DESIGNED BY: MARK YAMANAKA		C-D NOZZLE INLET JOINT ASSEMBLY		H	—
DATE: 8/1/2026				G	—
CHECKED BY: TBD				F	—
DATE: TBD				E	—
SIZE A2		PROJECT A: DFM PACKAGE		D	—
SCALE 1:1	WEIGHT (kg) 4.531			C	13/8/2026
DRAWING NUMBER CDN-000		SHEET 1/1		B	12/8/2026
This drawing is our property; it can't be reproduced or communicated without our written agreement.				A	9/8/2026
				—	6/8/2026

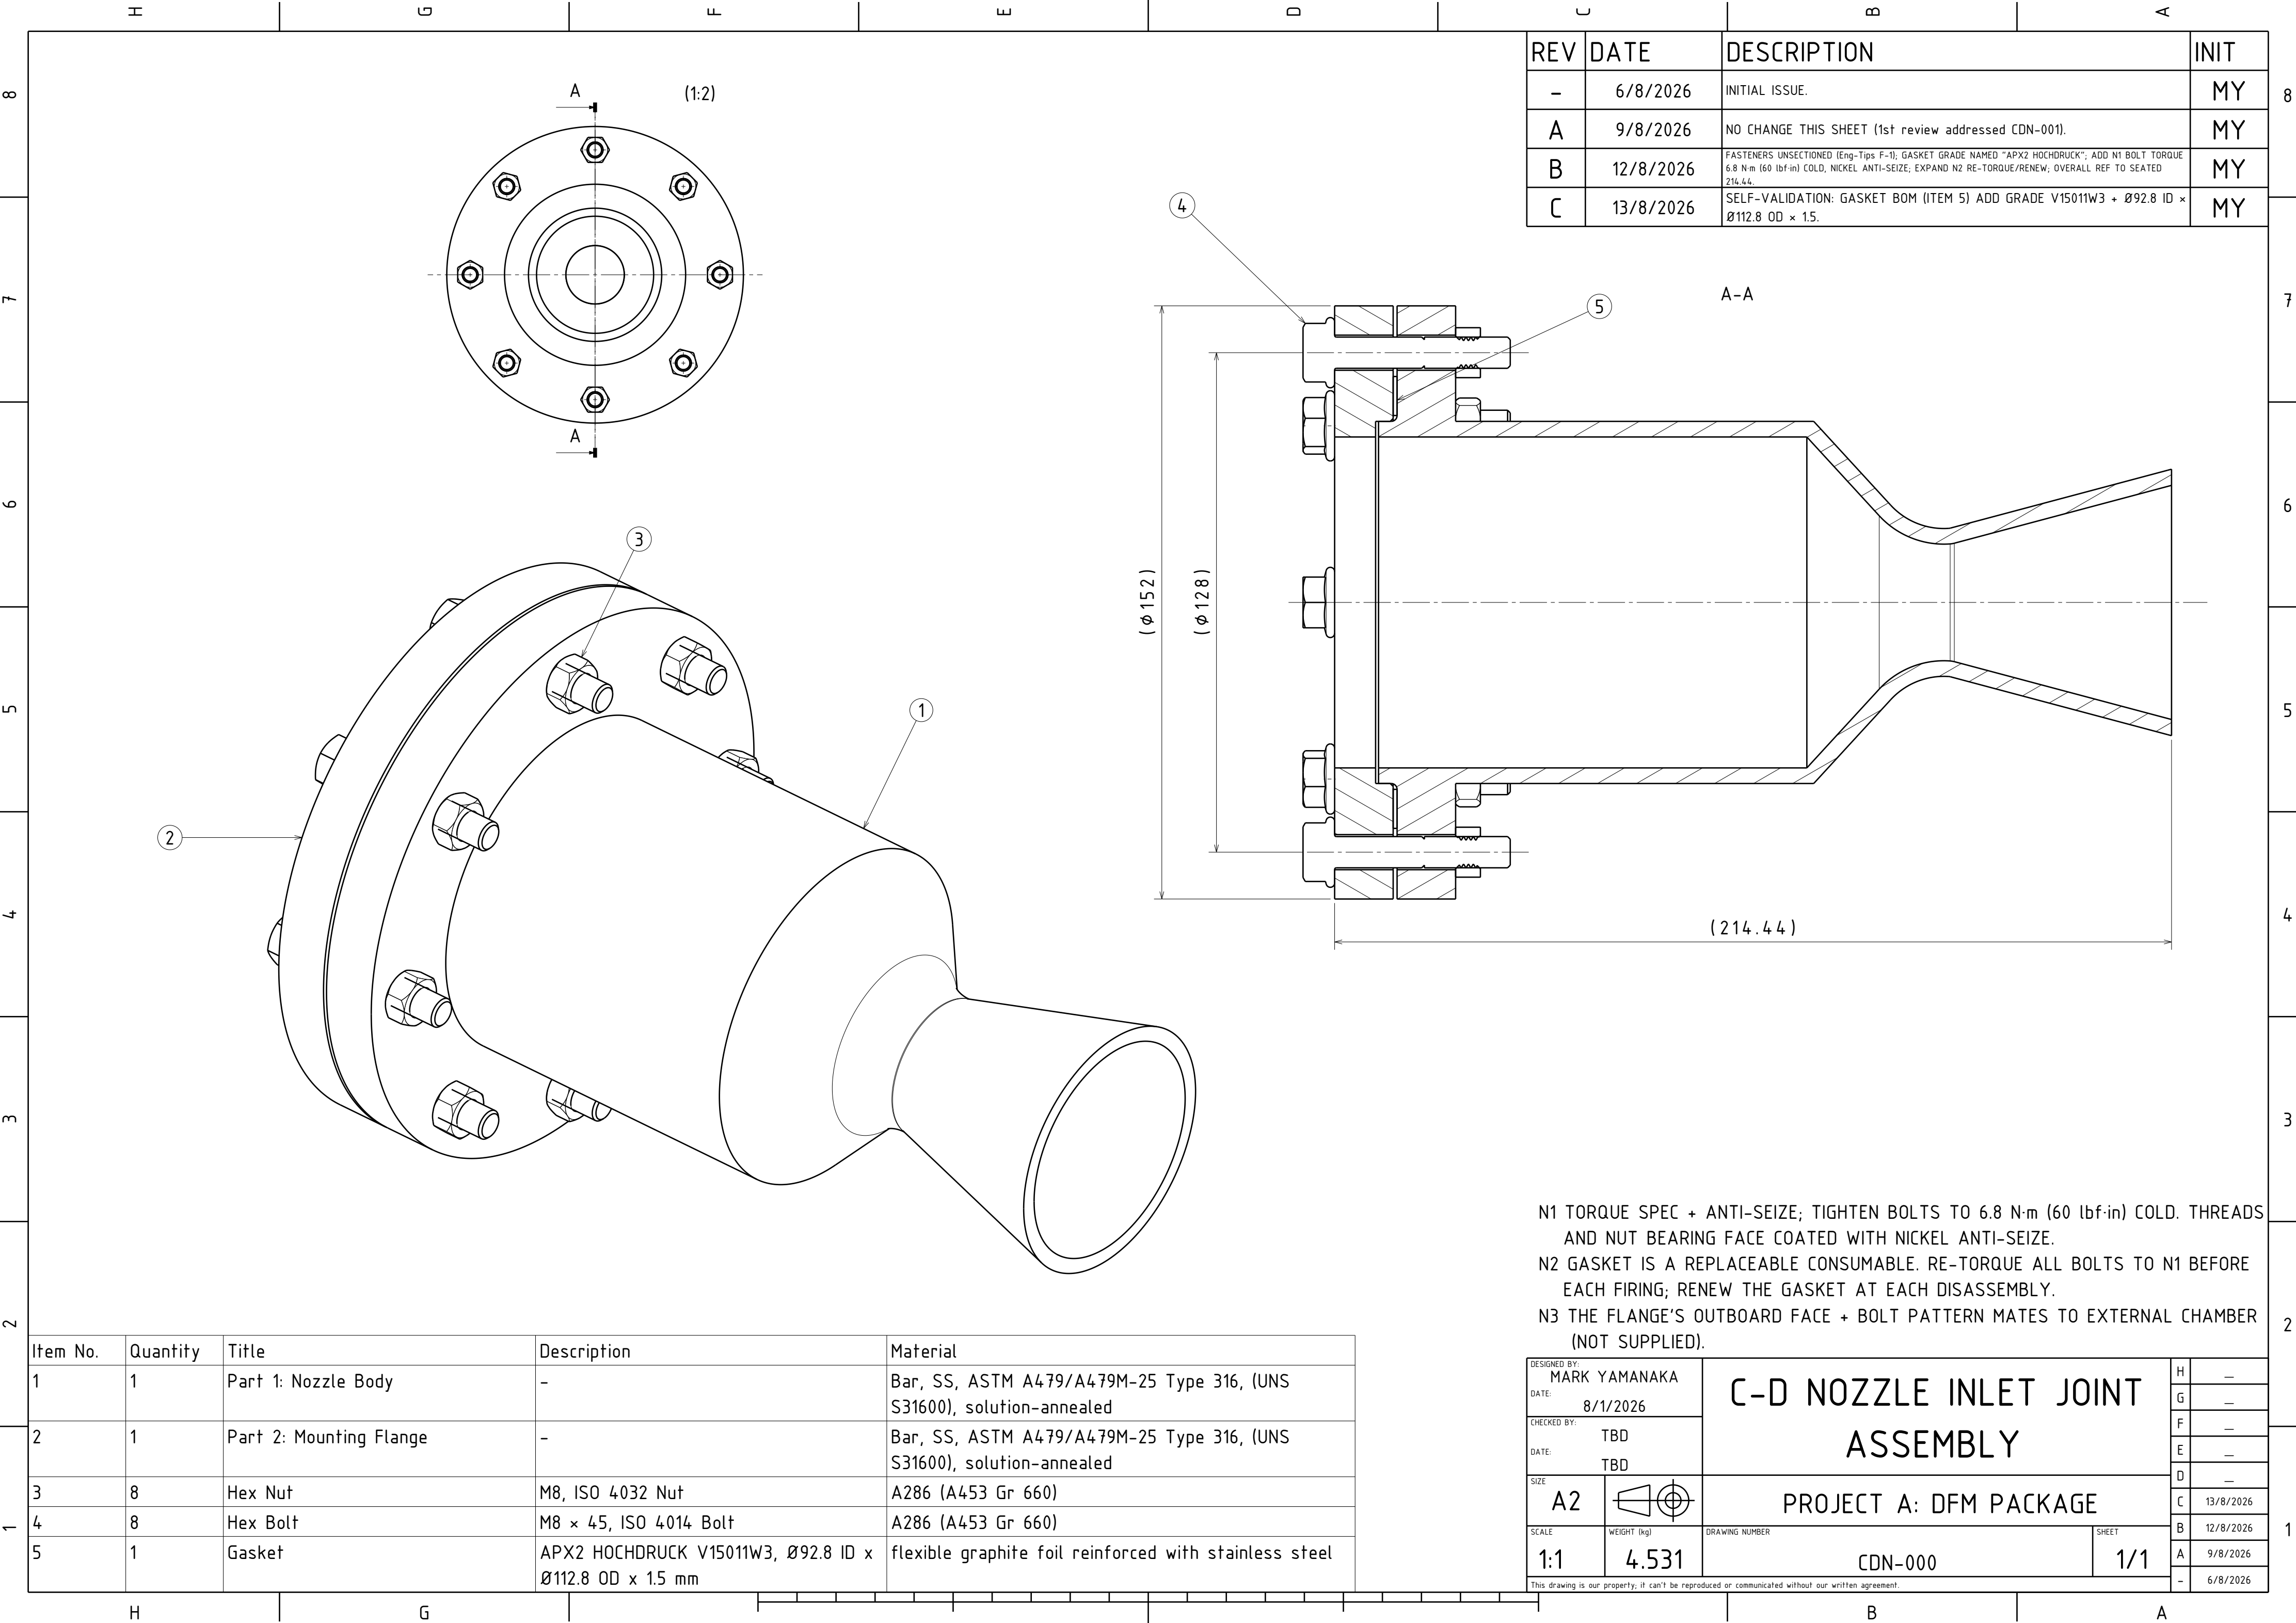
REV	DATE	DESCRIPTION	INIT
-	6/8/2026	INITIAL ISSUE.	MY
A	9/8/2026	NO CHANGE THIS SHEET (1st review addressed CDN-001).	MY
B	12/8/2026	FASTENERS UNSECTIONED (Eng-Tips F-1); GASKET GRADE NAMED "APX2 HOCHDRUCK"; ADD N1 BOLT TORQUE 6.8 N·m (60 lbf·in) COLD, NICKEL ANTI-SEIZE; EXPAND N2 RE-TORQUE/RENEW; OVERALL REF TO SEATED 214.44.	MY
C	13/8/2026	SELF-VALIDATION: GASKET BOM (ITEM 5) ADD GRADE V15011W3 + Ø92.8 ID × Ø112.8 OD × 1.5.	MY

N1 TORQUE SPEC + ANTI-SEIZE; TIGHTEN BOLTS TO 6.8 N·m (60 lbf·in) COLD. THREADS AND NUT BEARING FACE COATED WITH NICKEL ANTI-SEIZE.
N2 GASKET IS A REPLACEABLE CONSUMABLE. RE-TORQUE ALL BOLTS TO N1 BEFORE EACH FIRING; RENEW THE GASKET AT EACH DISASSEMBLY.
N3 THE FLANGE'S OUTBOARD FACE + BOLT PATTERN MATES TO EXTERNAL CHAMBER (NOT SUPPLIED).
